**Application by Highways England for M54 to M6 Link Road
Response to The Examining Authority's 3rd Written Questions and requests for information (ExQ3)
Issued on 29 Jan 2021**

**Response Deadline 6 - 12th Feb 2021
Responses From: Allow Ltd**

Appendices to accompany Allow Ltd's Response to ExA's 3rd Written Questions and requests for information (ExQ3) Issued on 29 Jan 2021

Allow Ltd's Alternative Woodland Mitigation Planting (WMP) Proposal

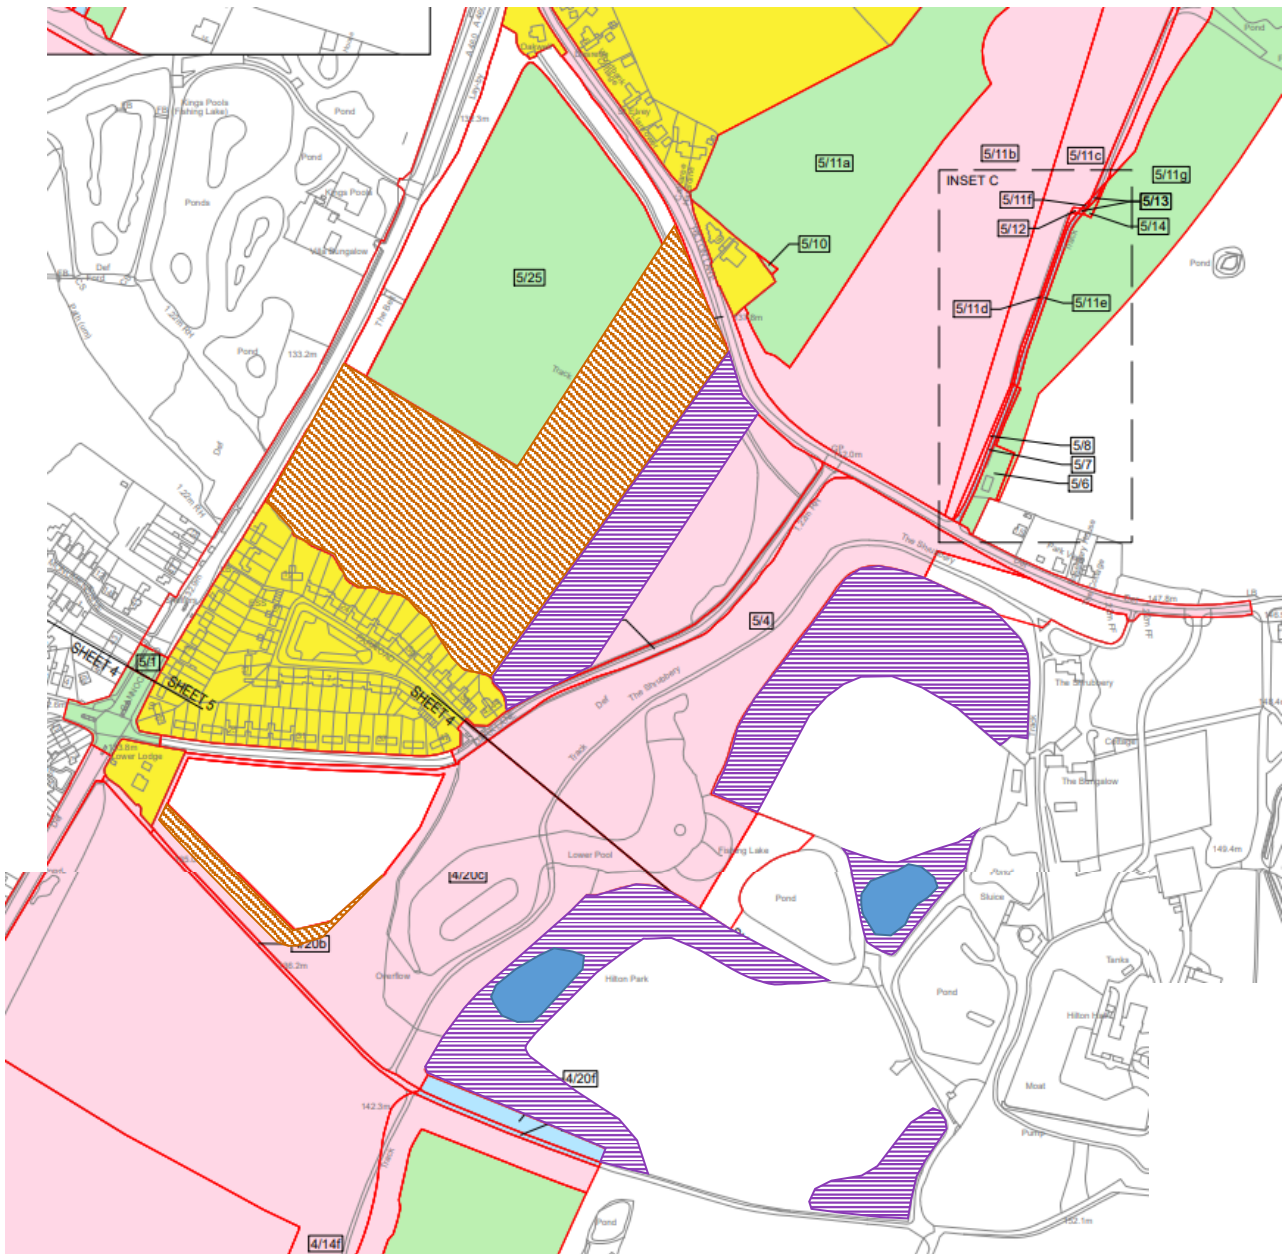
Could Allow Limited please provide the ExA with a copy of this proposed planting plan, and also provide, as early as possible, a copy to RCHME so that it can use that in its response to ExQ3.6.4(c)?

3.1 We attach a copy of the plan provided to the Applicant on 13th January 2021 following the site meeting with RCHME. A copy of the same plan was provided to RCHME on 3/2/21 as requested by the ExA.

7.19 The Allow option is much more nuanced and carefully considered than any of those put forward by the Applicant in TN 8.22. Part of the mitigation planting is retained within Plot 5/2 on the western side of the proposed new highway, as this provides visual screening of the scheme (including traffic) for residents of Featherstone and travellers using the A460 Cannock Road.

7.20 The remaining planting is all moved to the eastern side of the proposed new road. Some would be placed in the open land to the north-west of Hilton Hall and the Conservatory, extending north from Lower Pool and largely replicating the current sinuous boundary of the historic planting known as The Shrubbery. A considerable amount of the land here would be left open and it would be possible to retain the two veteran isolated trees here out with the mitigation planting. In the south-eastern part of this open area there would be a small ecology pond with additional mitigation planting adjacent.

7.21 Further mitigation planting would be placed within the open land to the south of Middle and Lower Pools, with the boundary reflecting the existing planting and then curving around to establish a southern strip (to the north of the historic access road leading to the Hall. A second ecology pond would be placed within this mitigation planting, close to Lower Pool. Another small area of mitigation planting would be placed in the south-eastern corner of this open area, to the south-west of the Hall. This additional mitigation planting in the south-eastern corner would not be visible from the Hall or Conservatory as a result of existing vegetation, thus it would not impact on views across the open parkland. Also, it would not be an isolated block of woodland as it would be directly adjacent to the current mature woodland to the east of here.

7.22 It should be noted that this option proposed by Allow is very much an initial design capable of some level of adjustment if required – all of the land here is within the ownership of Allow Ltd. The current design of the Allow option has considered the ecological requirements (i.e. the efficacy of the mitigation planting) as well as the historic landscape and the settings of the listed buildings. The ecology ponds are placed such that there is connectivity with existing

7.23 The impacts of the Allow option comprise the planting of trees and the establishment of ecology ponds within what have hitherto been areas of open parkland with individual trees (now veterans). Consequently, there is some loss of openness and also loss of legibility of the historic tree belt planting (The Shrubbery) as the new planting would be directly adjacent to the historic planting. However, the legibility of the perimeter tree belt along the western edge of the park (immediately east of the A460 Cannock Road within Plot 5/2) would be retained in full, whereas with the current (ES) scheme this would be partially lost. The sinuous boundaries of the proposed mitigation planting on the eastern side of the new highway reflect the historic ones.

7.24 A considerable amount of openness is retained in both the land to the north-west of the Hall and Conservatory and the land to the south of Middle Pool. The design of this option allows the retention of existing isolated (and veteran) trees within these areas of open parkland. More than that, however, it enables the planting of additional individual trees in these open areas to complement and ultimately replace the existing ones which are the surviving remnants of the designed planting. In their response to the ExA at Deadline 4, Historic England advised (with regard to the land east of the proposed new highway): *'This area of parkland is subdivided by 20th century ponds and surrounding planting, and has lost the majority of its open growing parkland trees, but still retains its parkland character, which could in part be recovered through restoration planting of individual parkland trees'*. This restoration planting would be possible within the Allow option. The Applicant has proposed restoration planting within Plot 4/20 (EM8 in the revised Environmental Masterplan – Repositioning of individual trees to match OS 1st edition 25'' map (1900-1902)), thus clearly this is seen as desirable. However, Plot 4/20 would be separated from the rest of Hilton Park (and the listed buildings) by the proposed new highway, whereas restoration planting in the retained open parkland to the east of the new road would be more beneficial both for the historic park and also with regard to the setting of the listed buildings.

7.25 The Allow option actually performs much better than the Applicant's Option 3 and Option 4 in terms of the impacts on the historic park, as it has been far more carefully designed with regard to the locations of the mitigation planting, the nature of the boundaries of the new planting (sinuous rather than straight), and the placement of the ecology ponds within areas
